CARRIAGE MEADOWS SOUTH AT LORSON RANCH FILING 2

**CARRIAGE MEADOWS SOUTH
 AT LORSON RANCH
 FILING NO. 2**
 El Paso County, Colorado
 PUD & PRELIMINARY PLAN

PCD FILE NO.: PUDSP-18-5

TYPICAL STREET CROSS-SECTIONS

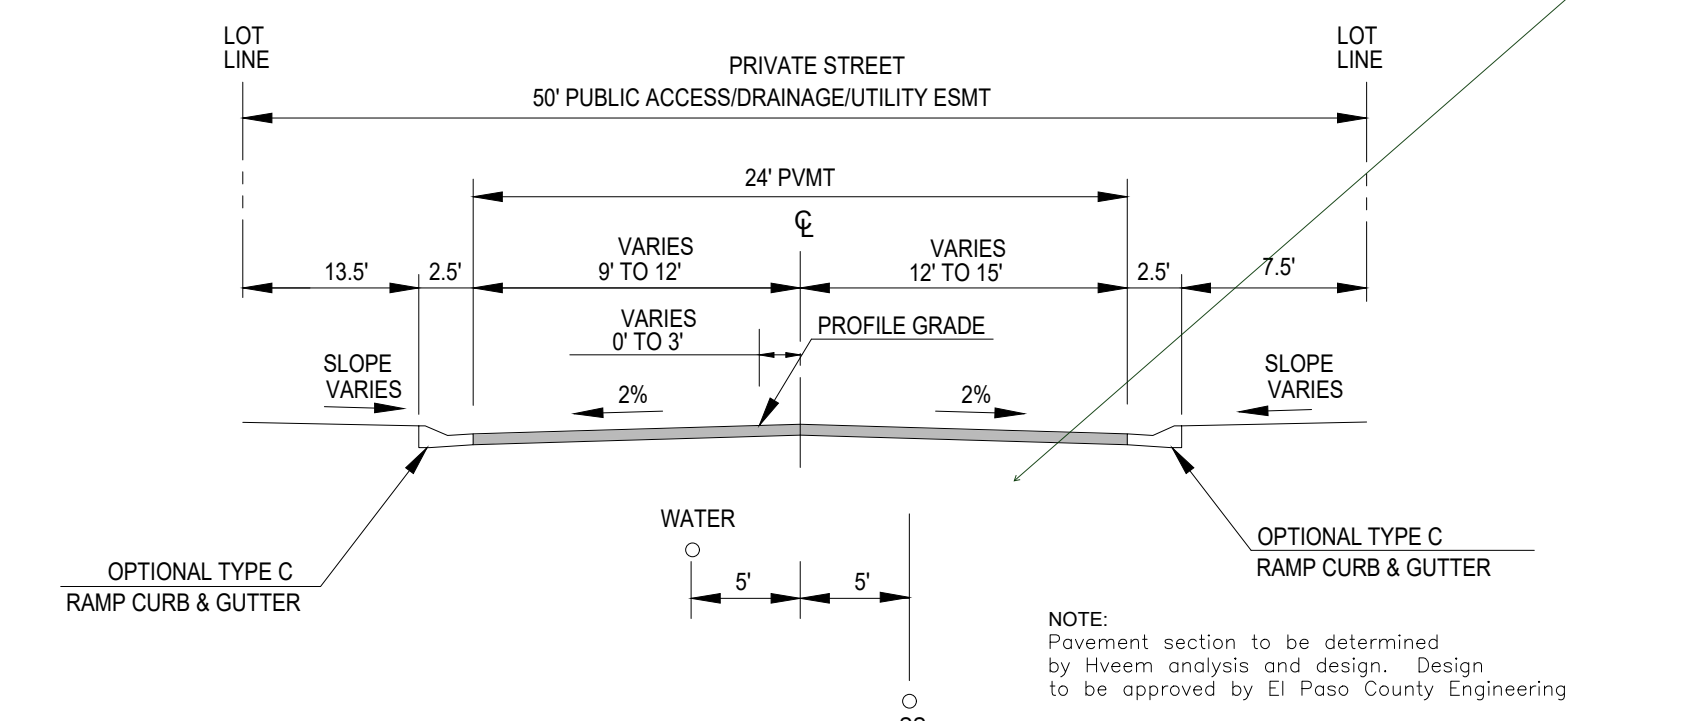
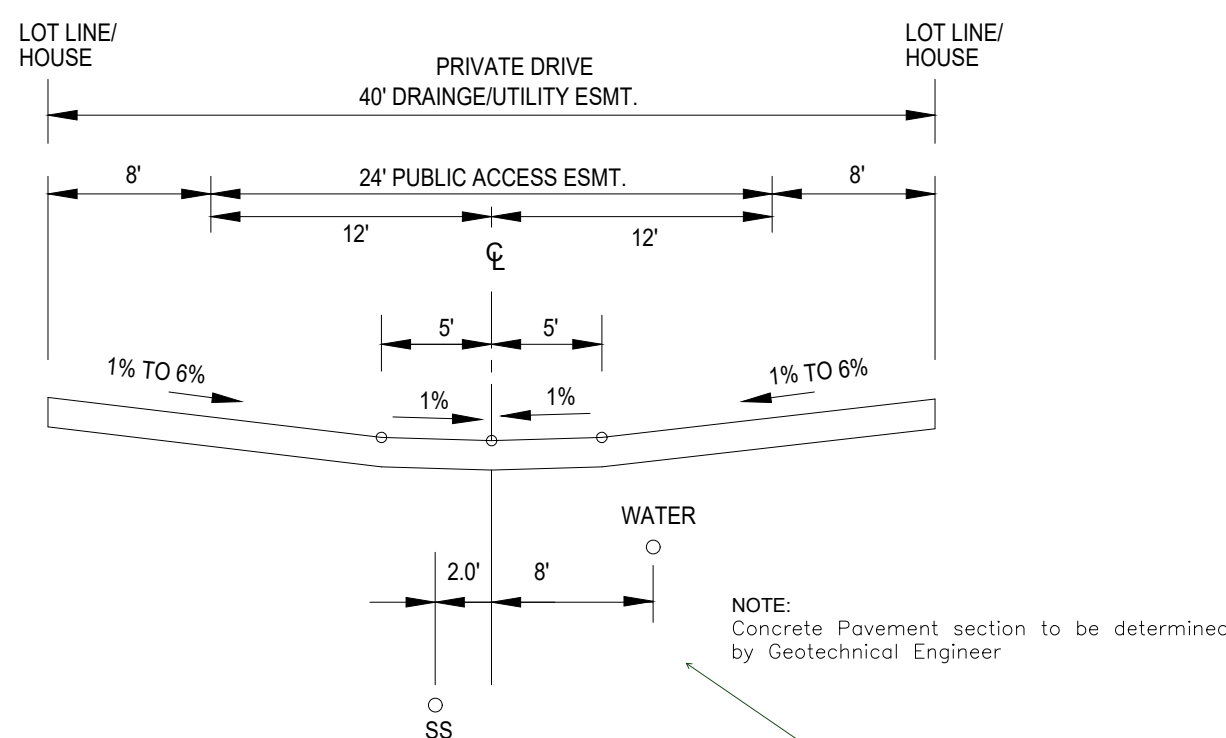
public ROW and Private road or drive?

TYPICAL LOT DIAGRAMS

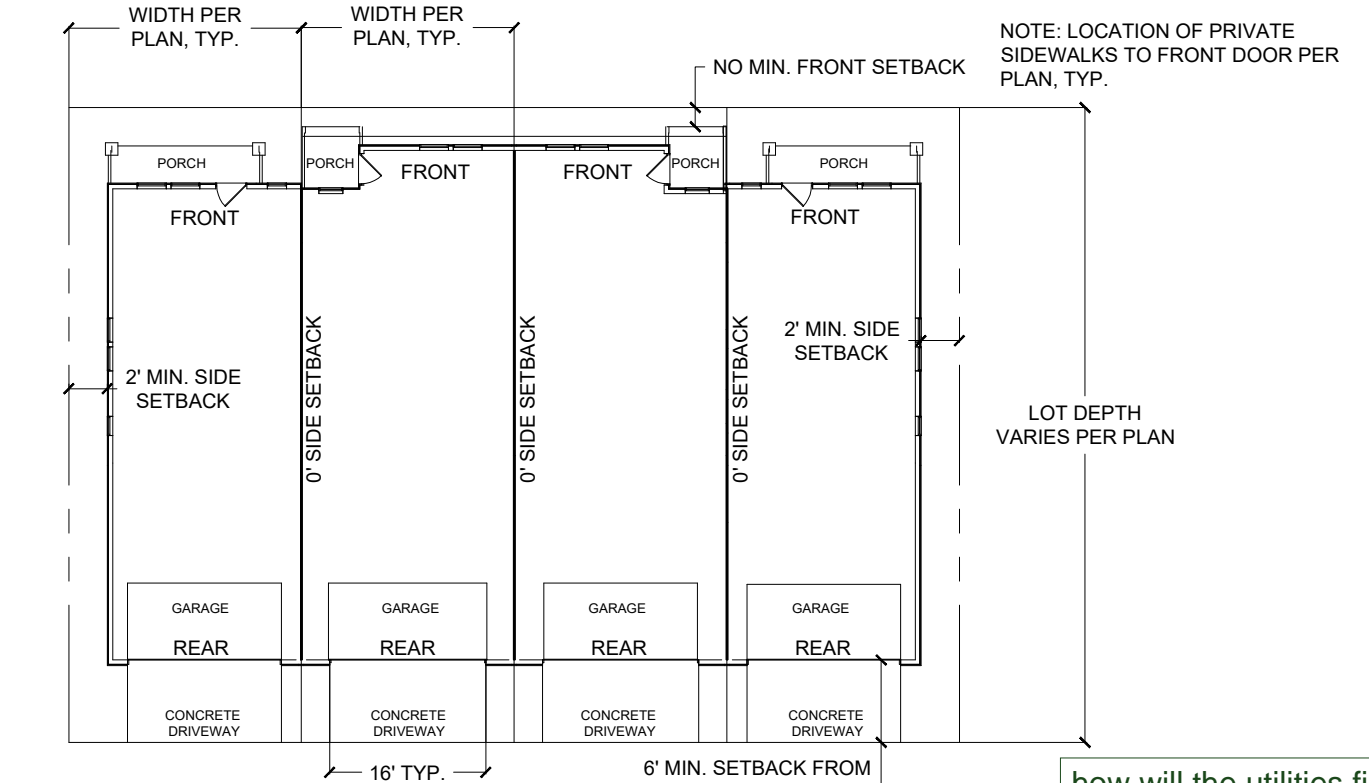
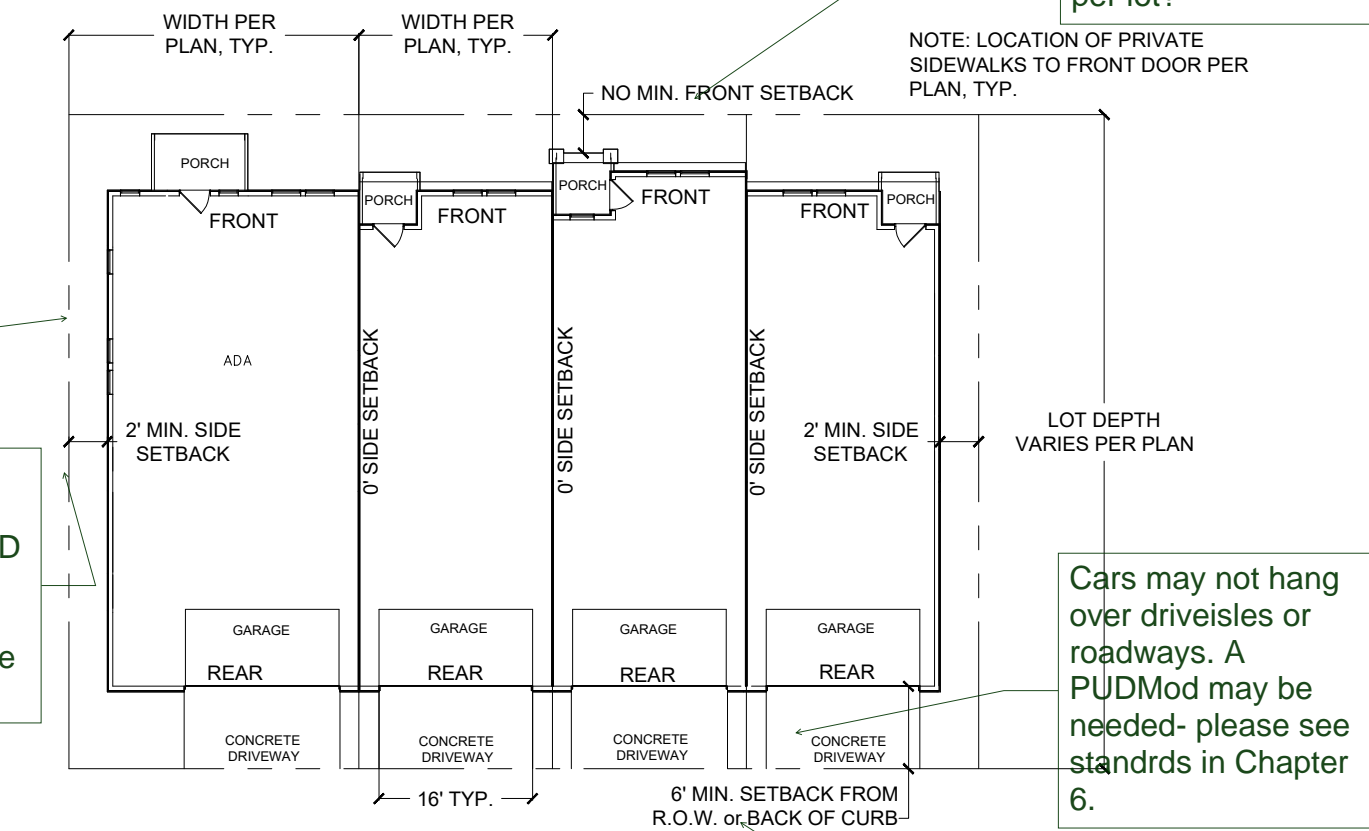
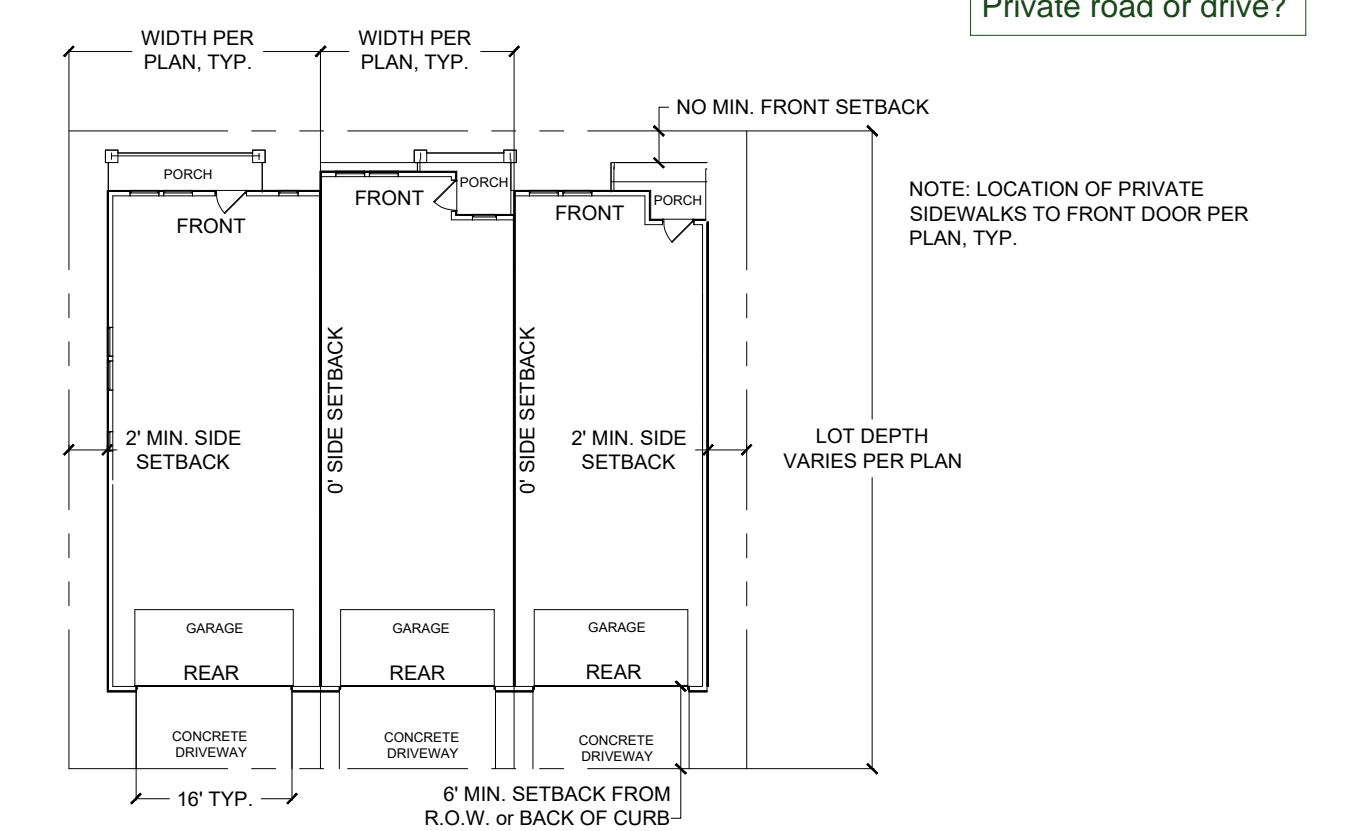
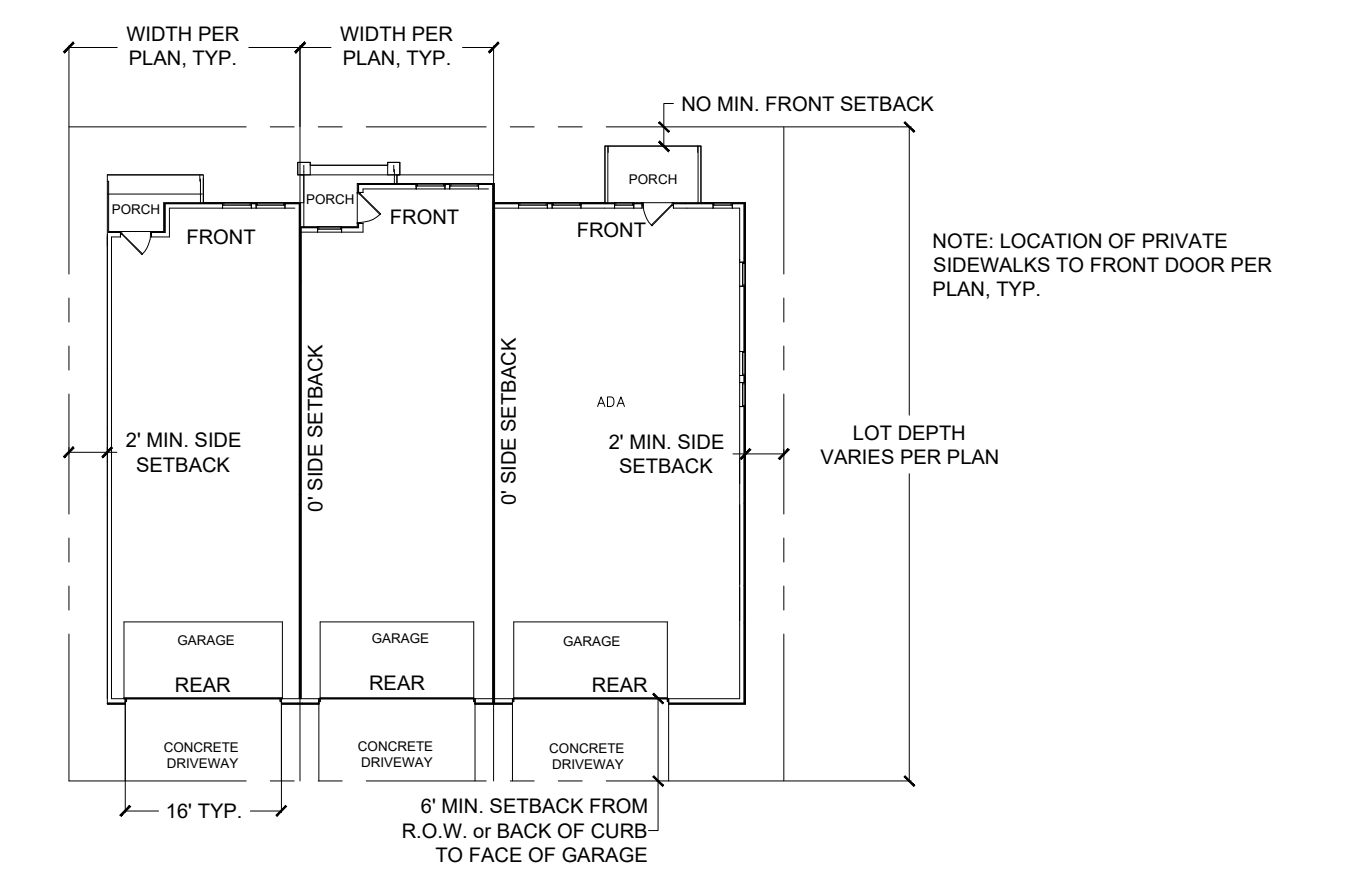
Provide a parking table: Justify the parking; identify how many bedrooms, and how many spaces included in garage and in a 10 foot driveway plus guest parking areas.

No Parking Signs-

Parking may cause a public safety concern. Provide a specific letter that the Fire protections district has no issues with on site street parking and length of driveway as overhang will block the roadway.

all these comments pertain to each detail to the right:

Are these lot lines? Depict the lot lines with one line type and label.

The end units may need 5 foot side backs. Does PPRBD require 1- foot separation between buildings irrespective of lot lines?

how will the utilities fir in with no setbacks? Where are the easements for utilities per lot?

Cars may not hang over driveisles or roadways. A PUDMod may be needed- please see standrds in Chapter 6.

SITE PLAN
P3 OF

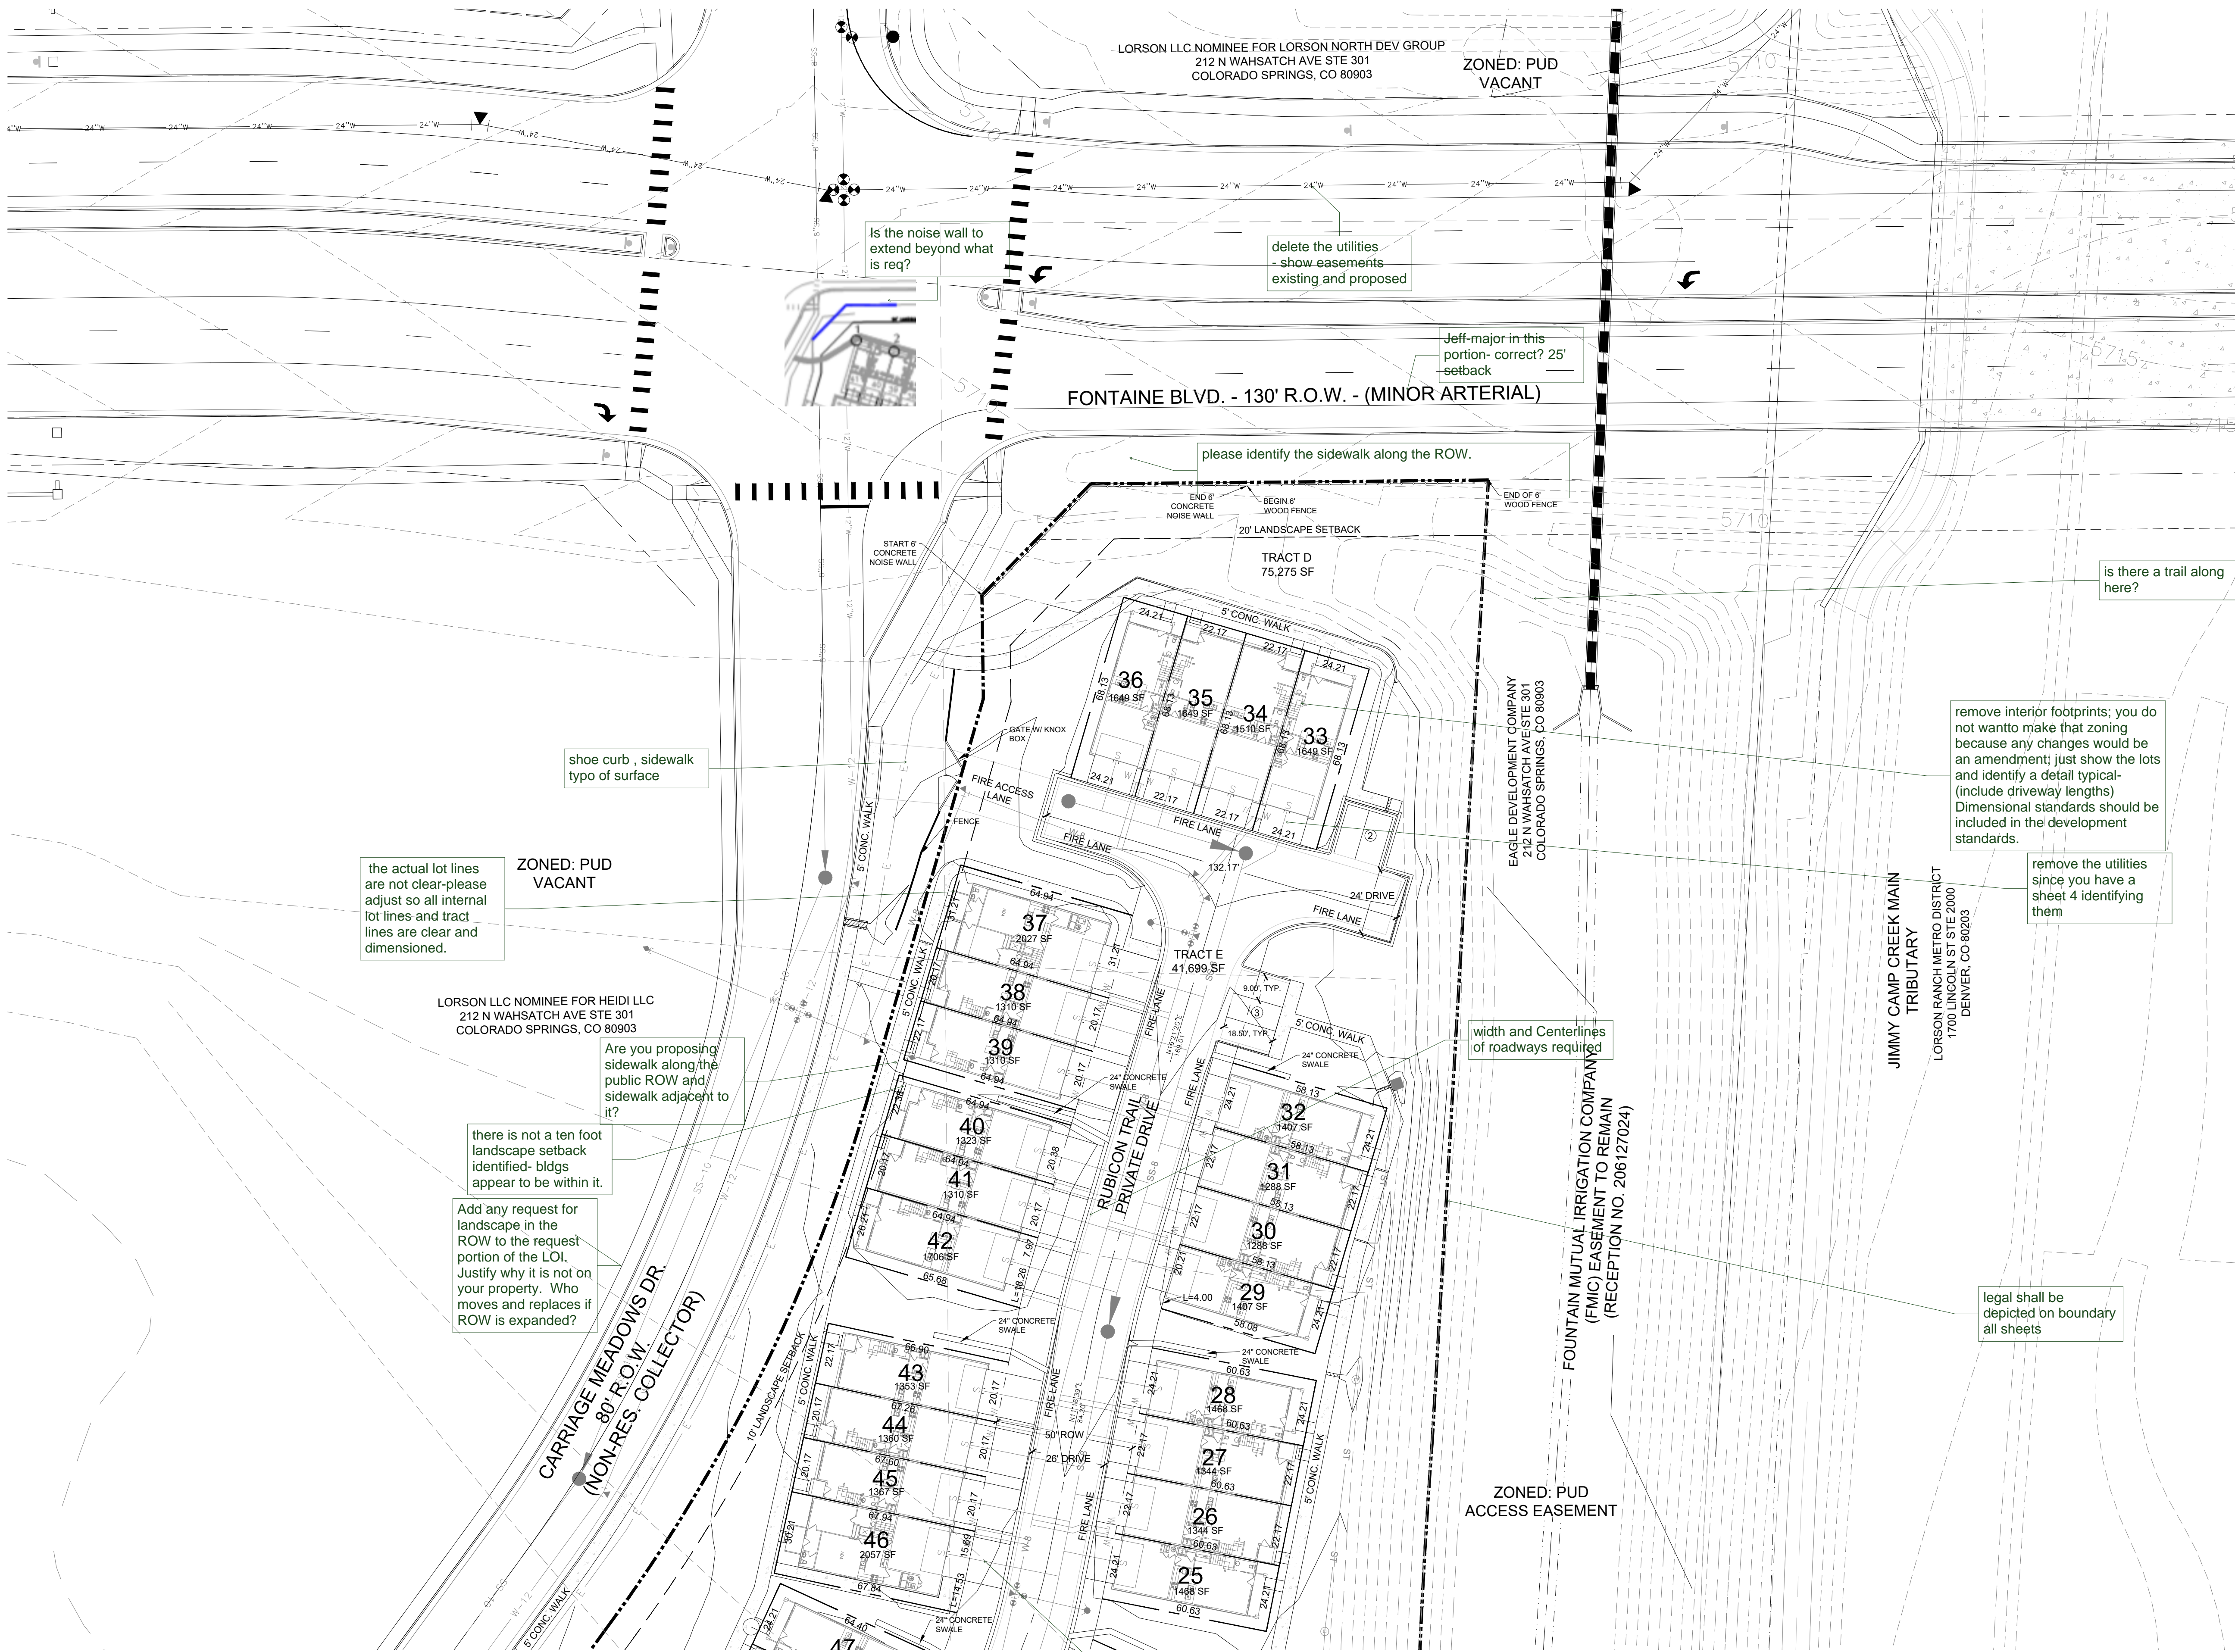
name of this sheet specifically is?
 STAMP:
